SUBJECT: Inclusive Park Assessment

Meeting Date:	September 8, 2021
То:	Parks and Recreation Commission (PARC)
From:	Commissioners Morris and Valadez, JEDI Subcommittee
Subject:	Enhancing Park Inclusivity Project– Park Assessment Report
Version 4.0

Enhancing Park Inclusivity

LAYC TOT LOT

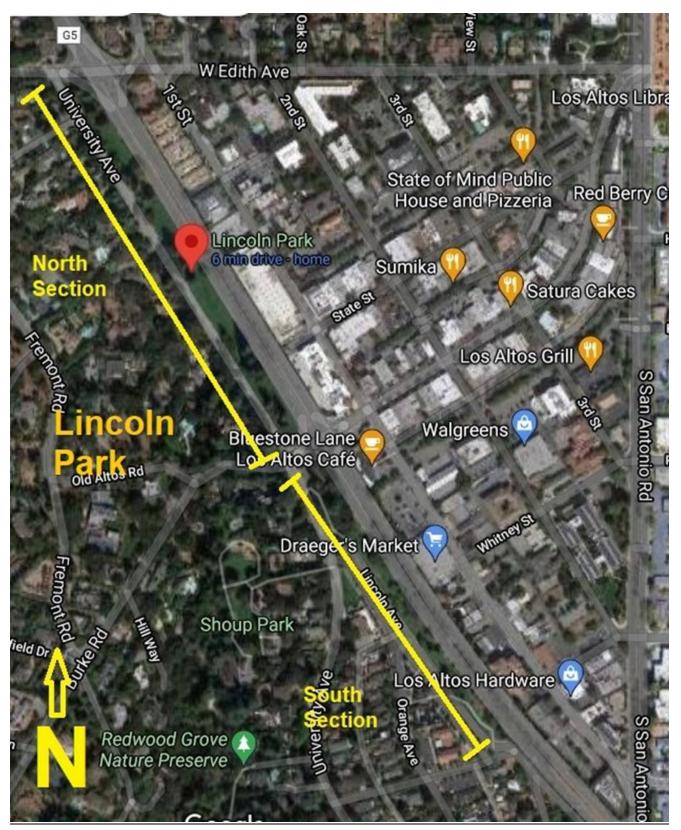
- Notes: Playground (2018) for Ages 0-2. Consider increasing shade options. Artificial surface pad located at the west side of the playground.
- Suggestion 1: Install one or more shade sails to shade southerly sun travel.
- Suggestion 2: Add additional artificial surface to music feature.
- Suggestion 3: Replace one of the bucket swings with an inclusive swing.

LINCOLN PARK

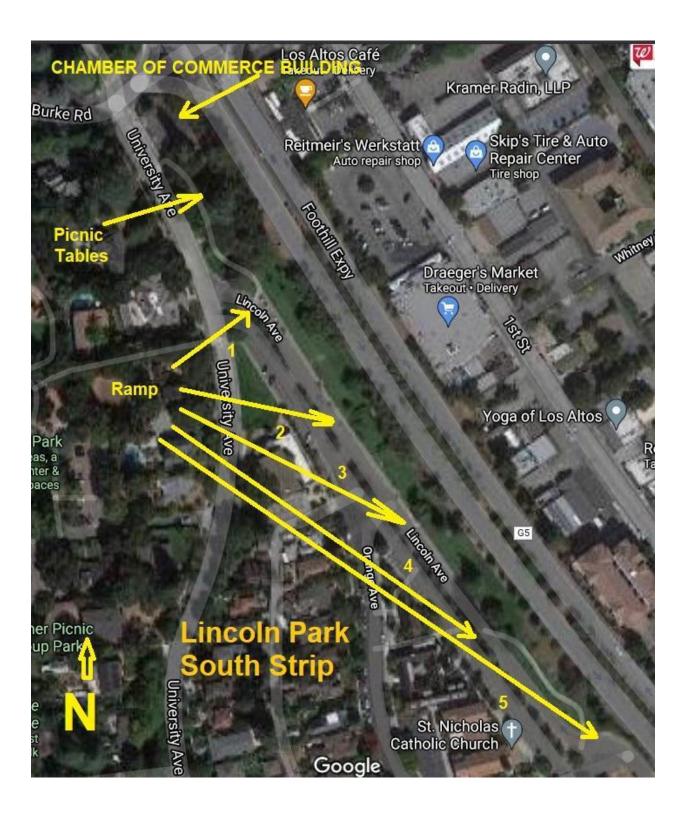
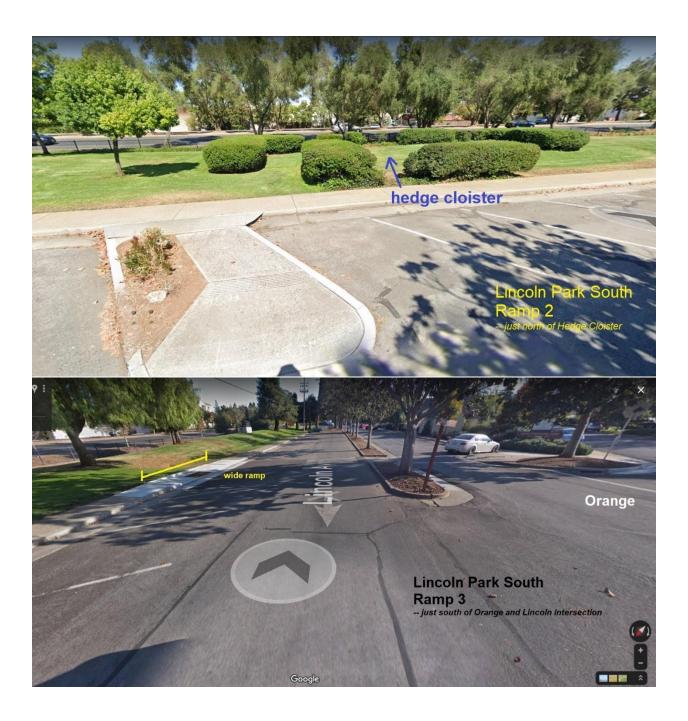
- Suggestion 1: Add wheelchair path from street and ramp access into Gazebo.
 - Suggestion 2: Add wheelchair-accessible picnic table under shade in grass area that backs on southeast end of Safeway store. This area can be accessed through Ramp 1 at nearby parking cutout (see picture). Add Handicap Parking designated space in cutout and wheelchair accessible pathway to table (granite fines over compacted earth, sealed).

- Suggestion 3: Convert existing picnic table, located at approximately 124 University, to be wheelchair accessible; add wheelchair path to simple ramp at curb and add Handicap Parking designated space.

- Lincoln Southern Strip (bounded by Foothill, Burke/Main, University, Lincoln)
 - Notes: Picnic area near Chamber of Commerce (COC) at northern end; two art sculptures/monuments further south; five (5) cement ramps from street up to sidewalk. Consider additional enablers for picnicking or seating.

- QUESTION for staff: is the COC building City property? Is COC housed on City Land?
 - QUESTION for staff: is the picnic table part of Lincoln Park or part of COC property?

- Suggestion 1: replace at least one picnic table near COC with wheelchair accessible table, or keep existing tables as is and add an additional Wheelchair accessible picnic table nearby ADA Ramp 1 near COC. Would require a wheelchair-accessible path from ramp to table; can be decomposed granite over compacted earth (sealed).

- Suggestion 2: Install 1-2 wheelchair accessible picnic (rectangular) or game (square) table(s) and wheelchair-friendly path further south along park near ADA Access Ramp 2, placed aside or within hedge cloister(hedges arranged in a quadrangle). This would be a sunny installation.

- Suggestion 3: Install 1-2 game (square) table(s) or picnic bench with adjacent wheelchair pad and path further south along park near ADA Access Ramp 4 under trees or on northeastern (Foothill Expwy) side of trees to afford afternoon shade.

Shoup Park Southern Playground -- "Dinette" Feature

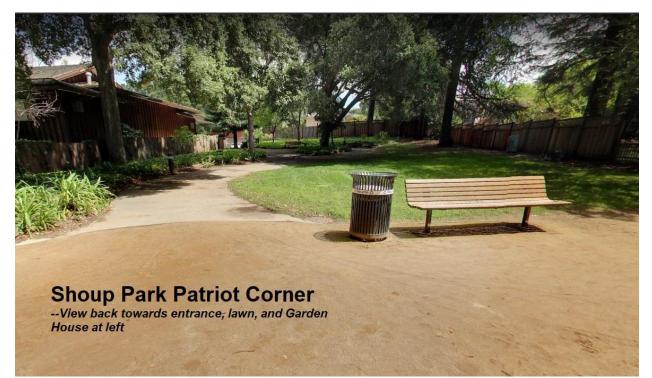
- Shoup South Playground (2004) nearest Parking Lot:
 - Notes: Consider additional inclusive play structure features; ramp into structure area descends to bark.
 - Suggestion 1: Add on-grade accessible path and platform to left side swings, replace one swing with inclusive version.
 - Suggestion 2: Resurface entire area left of ramp in soft rubber play surface and replace 1-2 swings with inclusive model(s).
 - Suggestion 3: Modify Dinette feature to accommodate a wheelchair; add on-grade accessible path and platform to Dinette feature.

REDWOOD GROVE

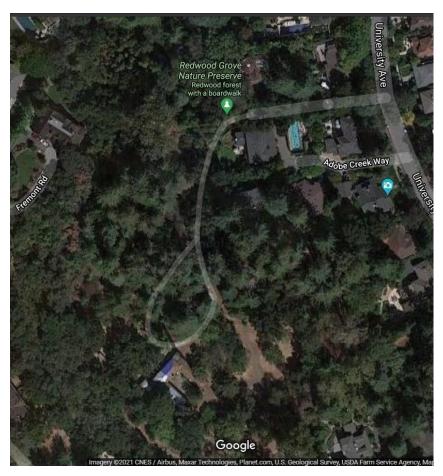
- Notes: The initial path into the grove is accessible. Consider uneven transitions on boardwalk. Consider increasing accessibility in other portions of the park. Halsey House area was not inspected.
- At this time, we defer any specific suggestions to increase inclusivity at Redwood Grove pending decisions about the park by other City departments/groups.

TINY TOTS SCHOOL AND PLAYGROUND AT THE SAN ANTONIO CLUB:

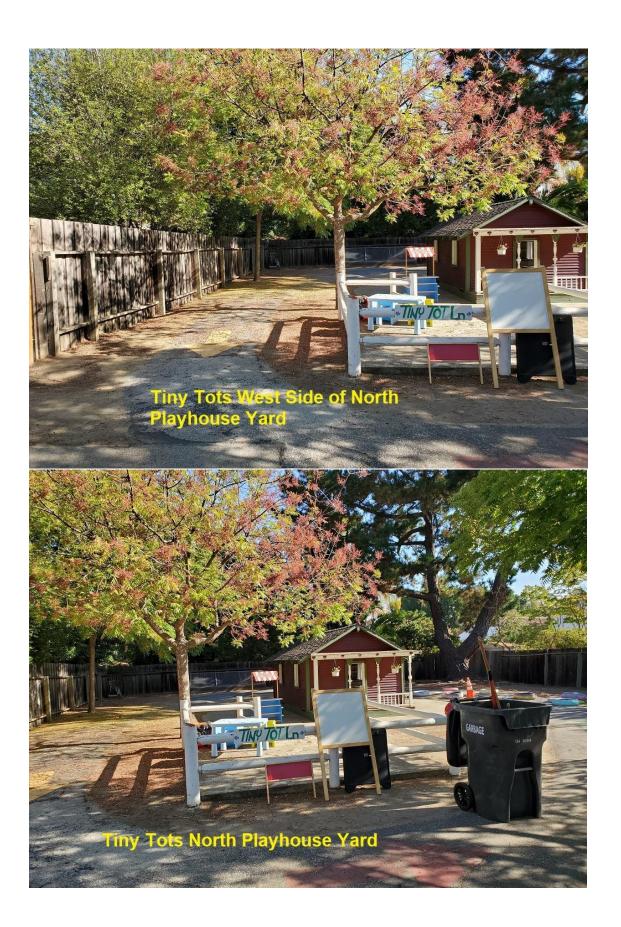
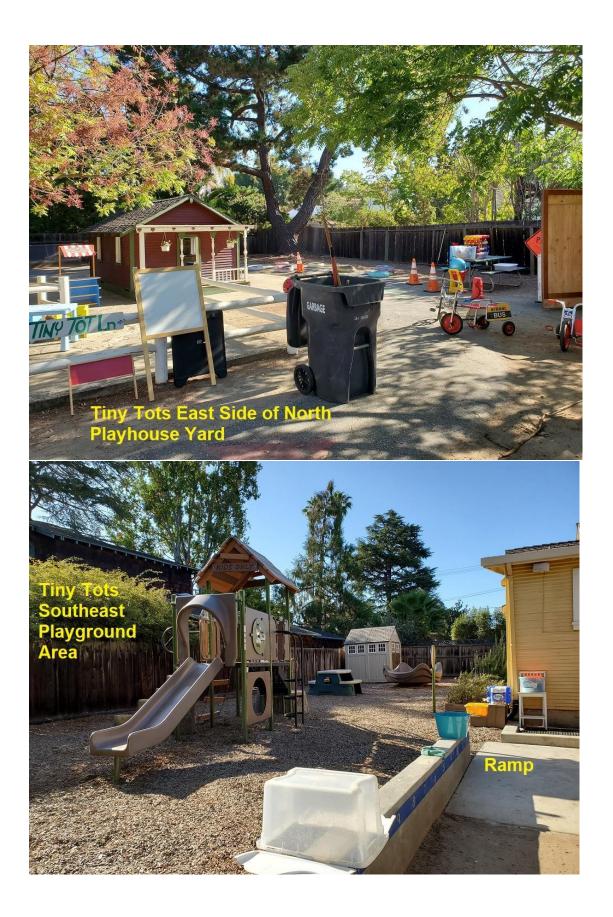
- Status: Due to lack of open public access, we are providing a more detailed description of this park. (Ignore cleaning supplies visible in pictures as the school was being prepared for opening.) Several excellent activities. Explore additional inclusive features including tables. Southeast Playground Area is in bark with play structure (2011) located at north end. There is a seamless concrete ramp to the bark grade (no curb). There is a semi-accessible merry-go-round (requires a lifted transfer to enter) at the south end. Consider enhancing accessible paths and accessibility to the mini-playhouse. Compacted earth and an asphalt path cover most of the rest of the ground surface, which is acceptable for wheelchairs, walkers, and crutches. Good shade everywhere sails and tree canopies -- EXCEPT over southeast playground area. As long as the programs do not extend into afternoon, this should be okay, but once all-day school is implemented, area becomes quite sun-intensive. This large yard has tremendous potential.

- Suggestion 1: Add on-grade accessible path to the merry-go-round.
- Suggestion 2: Install new inclusive activity feature in the northeast corner of the Playhouse Yard.

- Suggestion 3: Modify 1-2 activity boxes by elevating their height to be wheelchair accessible.
- Suggestion 4: Modify 1 picnic table to be wheelchair accessible.

- Suggestion 5: Add ramp from asphalt up onto playhouse platform; widen Playhouse entry to accommodate child's wheelchair.
